P93-130 - Laguna Meadows Apartments

REQUEST: A. Special Permit Time Extension to develop a 138 unit apartment complex within the Laguna Meadows Planned Unit Development (PUD) on 6.9± vacant acres in the Multi-Family (PUD) (R-2B{PUD}) zone.

- A. Adopt the attached Resolution approving the Special Permit Time Extension for one year to develop a 138 unit apartment complex within the Laguna Meadows Planned Unit Development (PUD) on 6.9± vacant acres in the Multi-Family (PUD) (R-2B{PUD}) zone.

SITE PLAN

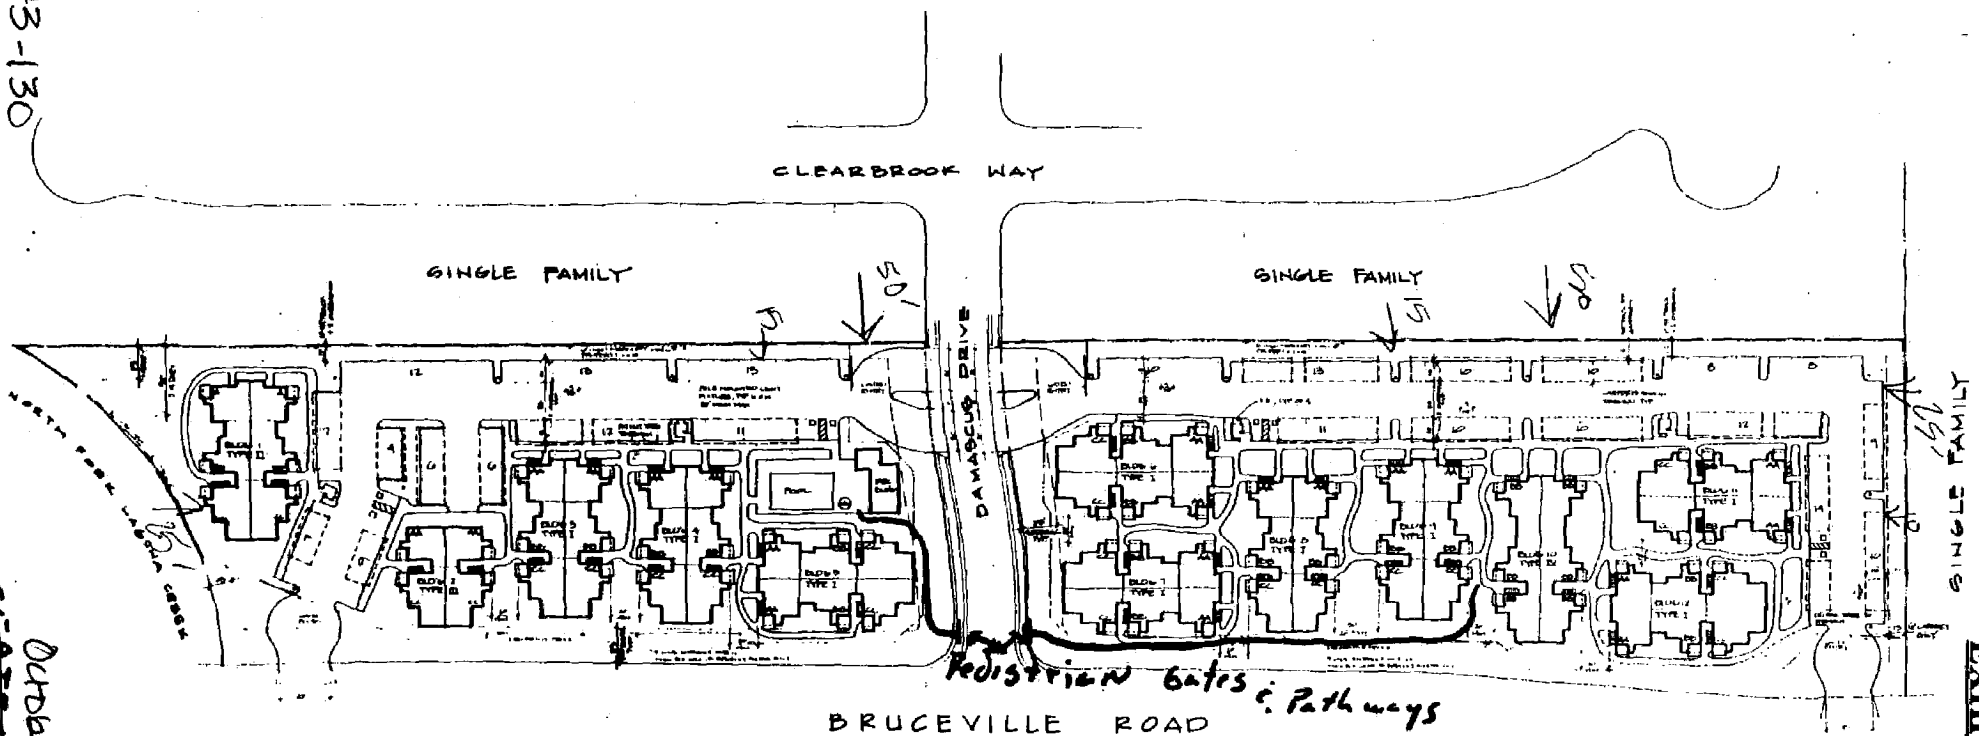
The proposed site consists of five parcels totaling 6.9± acres with three parcels located to the north of Damascus Drive and two parcels located to the south of Damascus Drive (see Exhibit A). The applicant is requesting a lot line adjustment to merge the three northern parcels into one parcel and the two southern parcels into one parcel. A lot line adjustment is necessary to prevent buildings being built across property lines. Combining the parcels also allows for better development of the site by permitting greater flexibility of design created by the larger parcel that two or three smaller parcels would not allow. The proposed parcel to the north (Parcel A) has a front setback area that is referenced from the south property line which fronts Damascus Drive. The parcel to the south (Parcel B) has a front setback area referenced from the north property line which fronts Damascus Drive. Staff supports the lot line adjustment.

The project consists of twelve buildings, containing 138 units of one and two stories. Also a part of the project is a recreation building and swimming pool on the south parcel and a tot lot on the north parcel (see Exhibit C). (The setbacks required in the Laguna Meadows PUD Guidelines have been met. This includes a minimum building setback of 50 feet and 25 feet for two story and single story structures, respectively from interior (west) and rear (north-Parcel A and south-Parcel B) property lines.) The PUD guidelines require ten foot and fifteen foot setbacks from the rear and interior property lines for open and covered parking stalls, respectively. The proposed plan meets these setback requirements for the open parking areas and carports. The proposed project also shows a 25 foot landscaped setback area along Bruceville Road and Damascus Road. This meets the PUD guidelines that require a 25 foot landscaped setback area along all street frontages.

The site plan indicates a six foot masonry wall along the west property line and the north property line of Parcel A. Staff recommends that this wall be a "Sacramento-Red" brick decorative wall compatible with other walls currently existing within the area. The wall along the west property line should continue to the street stepping down as necessary for visibility as it approaches Damascus Drive and then wrap around towards the single family development to the west. This will provide additional buffering for the adjacent corner single family lots to the west from the parking area and entrance/exits. There is a proposed decorative fence enclosing the project along all other property lines (see Exhibit C). The fence will be decorative wrought iron four to five feet high. The fence must meet all applicable requirements of the Zoning Ordinance.

There are two entrances to the project on each parcel. The primary entrance for the entire project is off of Damascus Drive. This entrance is a gated entrance and the only entrance for visitor access. Each parcel has a gated entrance/exit off of Bruceville Road for tenants only. The proposed entrance/exit off of Damascus Drive has 30 foot wide driveways for each direction. The driveway width exceeds the width for driveways allowed by City Code which is a 25 feet for each direction. Staff recommends the driveways be reduced in size and the remaining area be landscaped to provide additional buffering for the adjacent residential properties to the west of the entrance area.

The site plan does not reflect a pedestrian walkway or access point at any entrance/exit location. Staff has previously recommended a pedestrian walkway through the landscaped area to the sidewalk be provided on both parcels at the intersection of Bruceville Road and Damascus Drive to minimize pedestrian/vehicle conflict in the driveway areas; to minimize midstreet crossings on Damascus Drive; and to facilitate pedestrian traffic in and out of the project at an intersection protected by a signal. These entrances will also allow access to the apartments near the proposed bus stop on Damascus Drive.

- 1. The six foot masonry wall along the west property line and the north property line of Parcel A shall be a "Sacramento-Red" brick decorative wall compatible with other walls within the area. The wall along the west property line shall continue to the street stepping down as necessary for visibility as it approaches Damascus Drive and then wrap around towards the single family development to the west. The revised site plan shall indicate the exact location of the wall. The design and building materials for the wall shall be submitted for review and approval by the Planning Director prior to the issuance of building permits.

4. The applicant shall provide a decorative pathway from the recreational facilities to the intersection of Damascus Drive and Bruceville Road with a pedestrian access gate in the fence on both parcels. The pedestrian pathway shall be reflected on the revised site and landscape plans to be reviewed and approved by the Planning Director prior to the issuance of building permits.

13. The driveways off of Damascus Drive shall be reduced in size to meet City Code and the remaining area shall be landscaped. The revised site and landscape plans shall show the narrower driveways and the increased landscaped area. The entrances/exits off of Bruceville Road shall be for tenants only.

PRELIMINARY LANDSCAPE PLAN LAGUNA MEADOWS

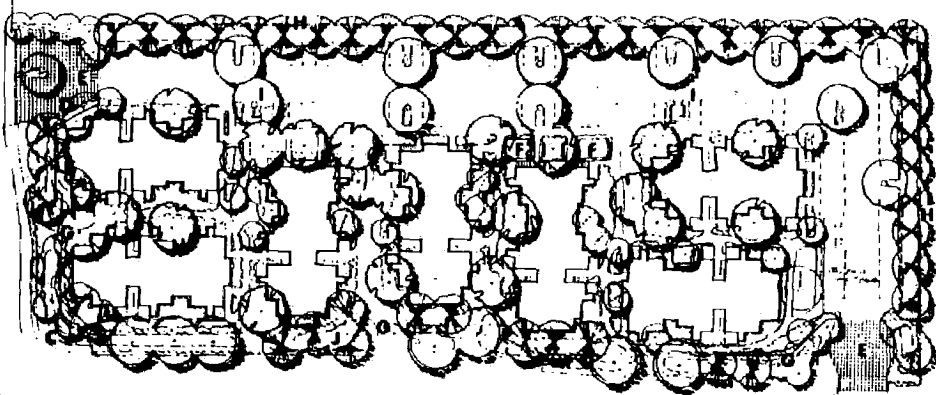
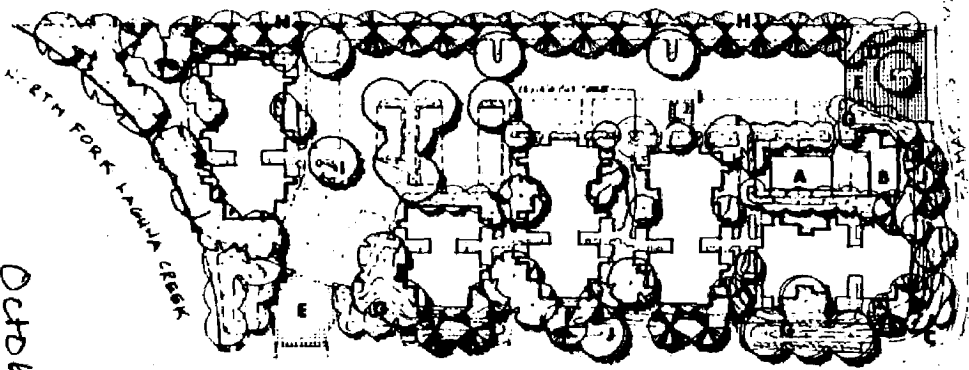
The applicant has submitted a landscape plan for the project which meets the majority of the PUD guidelines (see Exhibit D). The breakdown of specific locations for the various types of low shrubs is not indicated. Staff recommends that shrubs of a variety which has thorns and/or prickly leaves be planted in the areas beneath first floor windows, thus meeting the specific criteria for landscape treatment established in the PUD guidelines.

- 2. The applicant shall plant shrubs of a variety which has thorns and/or prickly leaves in the areas beneath first floor windows and these plants shall be specifically indicated on the landscape plan submitted for review and approval by the Planning Director prior to the issuance of building permits.

8. The applicant shall provide accent trees in front of the recessed portion of the building plans located off the master bedroom in Unit B. These trees shall be shown on the revised landscape plan.

CARPORT STRUCTURE

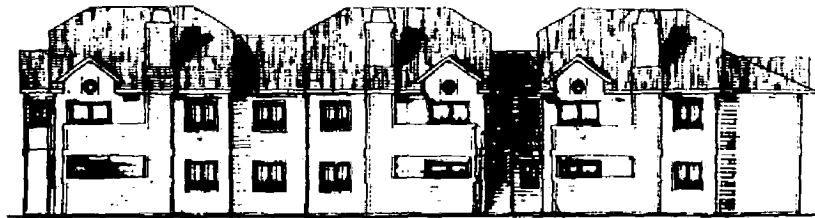
The proposed carports have a flat roof. The PUD guidelines discourage flat roofs and encourage pitched roofs or other roof variations. Staff recommends the carports be redesigned to have a pitched roof or other roof variation. (An example of two types of variations is attached as Exhibit N.) The carports should be compatible in design and materials with the main buildings.

6. All parking spaces along the west property line on both parcels shall be covered parking and meet the setback requirements for covered stalls. The carports shall be redesigned to have a pitched roof or other roof variation. The carports shall be compatible in design and materials with the main buildings. The covered stalls and the revised carport design shall be shown on the revised site plan and elevations to be reviewed and approved by the Planning Director prior to the issuance of building permits.

EXHIBIT H

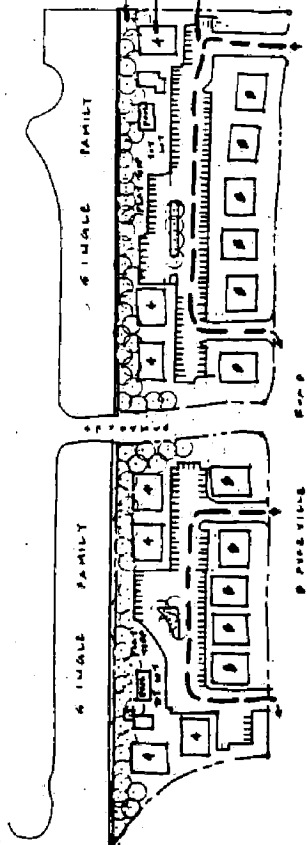
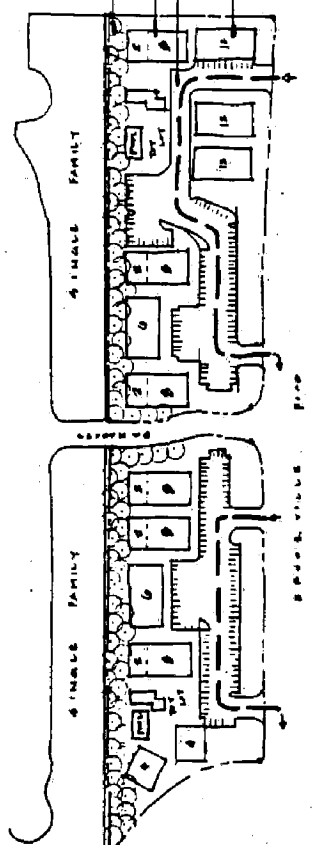
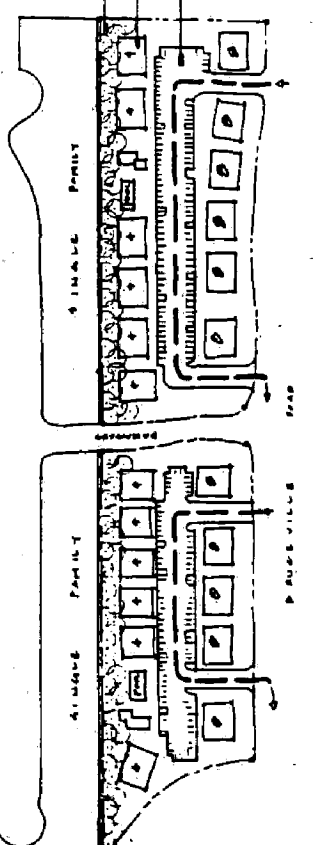
The three alternatives proposed by the neighborhood association are different variations of a parking and circulation flow pattern that places all entrances and exits for the entire project off of Bruceville Road with no entrance or exit off of Damascus Drive. This proposal was reviewed by Traffic Engineering staff (see Exhibit J) and was found to be inconsistent with the street and traffic plans for Bruceville Road. There is a proposed signal for the intersection of Bruceville Road and Damascus Drive to assist with the traffic in and out of the single family subdivision and the apartment complex. Traffic Engineering requires the primary exits for both

parcels of the project be off of Damascus Drive. Bruceville Road is to be a six lane major street with limited access and only right turns into and out of the complex onto Bruceville Road will be permitted. Also, the access to the apartment complex off of Bruceville Road is limited to tenants only to prevent any stacking or traffic disruption on Bruceville Road. The proposed alternatives also have entrance/exit location too close to the intersection as specified by City Code. The use of Bruceville Road as a sole entrance/exit means for the apartment project would create an unacceptable level of "U" turns having to be made along Bruceville Road. It is the Traffic Engineering's intention by requiring the primary access to the apartments of Damascus Drive to provide left turn capability at the proposed signaled intersection of Bruceville Road and Damascus Drive, thus significantly reducing the need for "U" turns on Bruceville Road.

The proposed alternatives provide a design of buildings that are linear in nature due to the orientation of the parking plan. This design proposal does not meet the PUD guidelines. Two of the alternatives reduce the number of units from 138 to 116. The reduction of units still falls within the required density requirements of both the General Plan and the South Sacramento Community Plan; however, staff recommends the number of units be maintained as proposed by the applicant and the PUD guidelines to prevent further housing loss in the South Sacramento Community Plan area and city wide. Staff was unable to evaluate the proposed alternatives for other PUD guidelines compliance such as setbacks, parking stalls and maneuvering area, and landscaping and shading requirements since the proposed alternatives were conceptual and not to scale.
